November 13, 2020

Re: Sierra Club's Comments on Vectren's 2019/2020 Integrated Resource Plan

Figure 1: Vectren IRP Demand Forecast

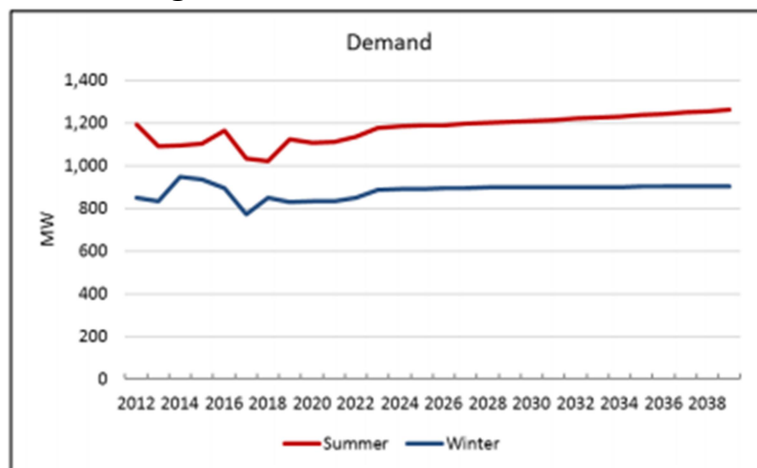
Second, Vectren’s projection of increasing load during the 2020s, especially an abrupt jump upwards around 2025, is unsupported and should be reevaluated before the Company invests significant customer funds into the construction of peaking resources.

Vectren’s projection of significantly increased load is in stark contrast to the decreasing demand that the Company has experienced for the last decade and in particular the last three years. In Figure 7.1 in the IRP, Vectren’s reference load forecast begins at 5.4 million MWh in 2020. Its 2019 sales were 4.7 million MWh (a discrepancy with the 2020 load forecast of 15%!) and the 12-month rolling total through Aug 2020 has fallen to 4.5 million MWh (due in part to the pandemic).

Figure 2: Sales by Section, Rolling 12-Month Total (million MWh)

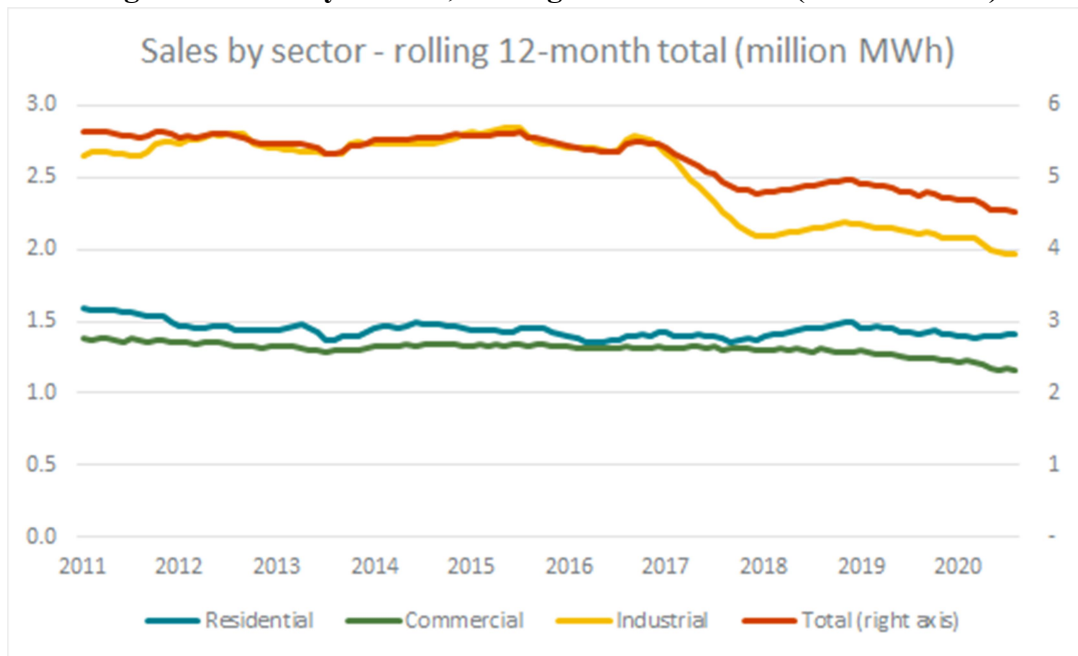
Most strikingly, the industrial customer segment has shown a dramatic decrease in demand in recent years. Residential and commercial demand has been flat or slightly declining. Vectren studied the mean absolute error for its past energy requirements forecasts for each customer segment and found errors of -1.5% for residential, -7.2% for commercial, and -3.2% for industrial comparing 2016 IRP forecast for 2018 levels to actual 2018 levels.¹⁵ In other words, Vectren’s past load forecasts have all been incorrect in the same direction: projecting load that is too high.
